Access Compliance Report

Public Rights-of-Way

(Curb Ramps)

| Intersection ID: 8589 | Main Street: BRADFORD_DR | Cross Street: WILLARD_ST | Location: S |

| ADA ID: B1062A7BB560 | Ramp Type: Perp | Initial Pass/Fail: Fail | Overall Compliance: No |

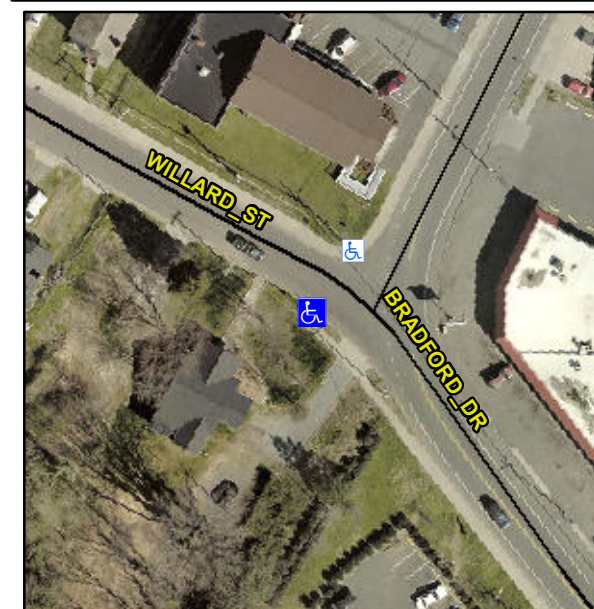
Not Found, R304.2.2, R304.5.3

| Compliance | Description | Data | Compliance | Description | Data |
|------------|-----------------------|-------|------------|-----------------------------|------|
| N/A | Ramp Length (in) | 50.0 | No | Ramp Slope (%) | 11.4 |
| Yes | Ramp Width (in) | 71.5 | No | Ramp XSlope (%) | 2.6 |

Remove & Replace Entire Ramp.
